ADDENDUM (13 APRIL 2021)

A (13.04.21): AJS recommended retaining wall section added to drawing.		Rev:			
Project:		Planning Submission Retaining Wall, at:			
Site:		High Lane, Brown Edge Stoke on Trent, Staffs.			
Title:		Proposed Elevation & Site Plan.			
Client:		Gowar Group LLP, St Matthews Business Centre, Gowar Street, Leicester, LE1 3LL.			
Date:	Scale:	Drawing No:	Rev:		
February 2021	1:100, 1:500 & 1:1250 @ A2	1399/ A2/01	1

RETAINING WALL NORTH WEST ELEVATION FROM CAR PARK

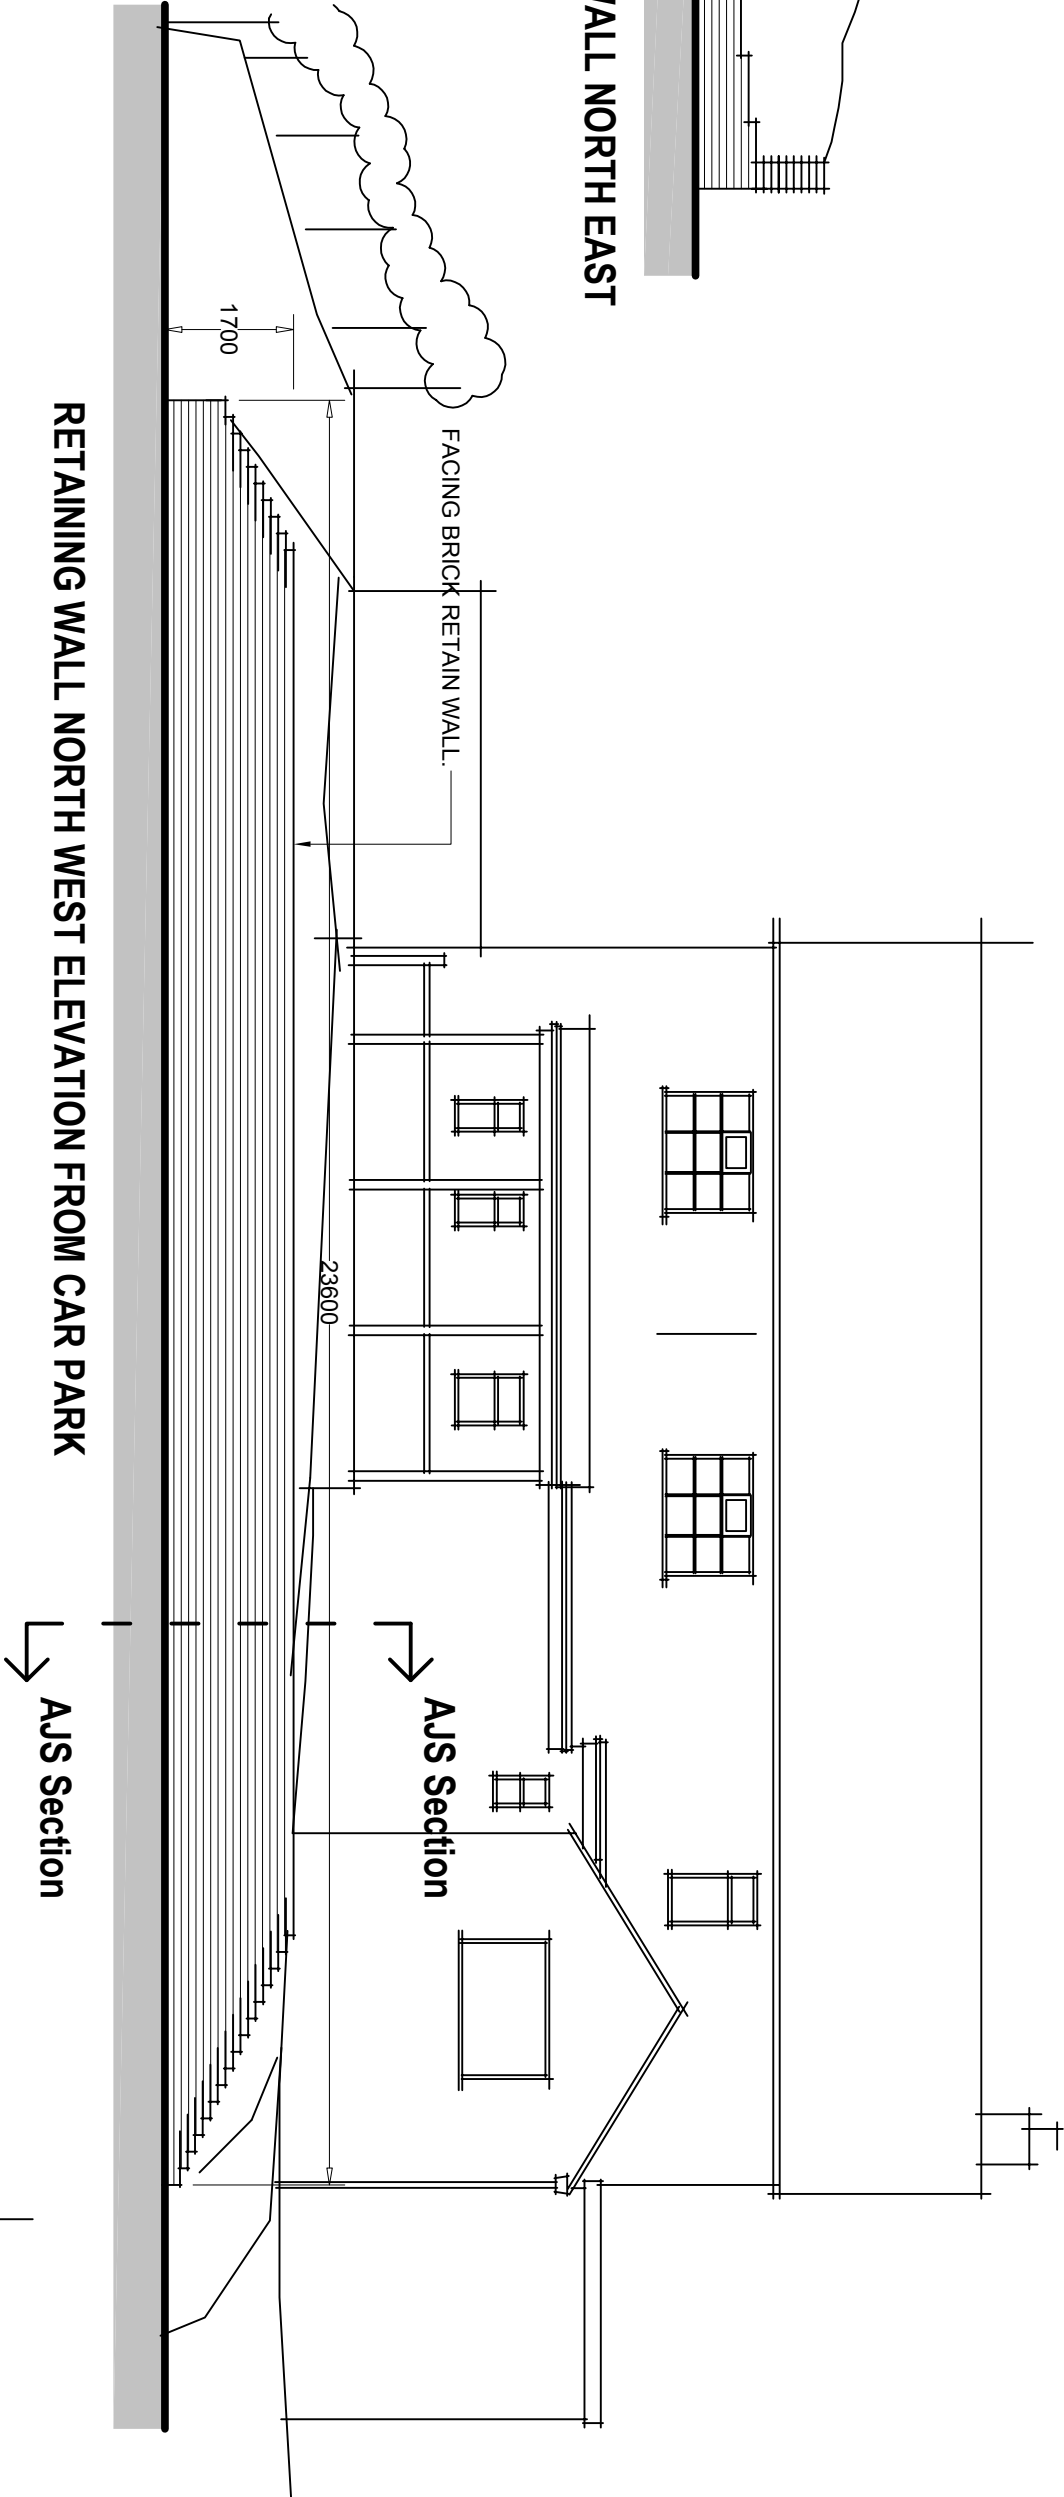
Following our discussion on 13 April 2021, I am happy to confirm that it would be acceptable for the new retaining wall to be constructed behind the line of the existing wall so that the existing foundation would not need to be broken out and removed. The base of the wall would therefore move back towards the main road by ~500mm (see below).
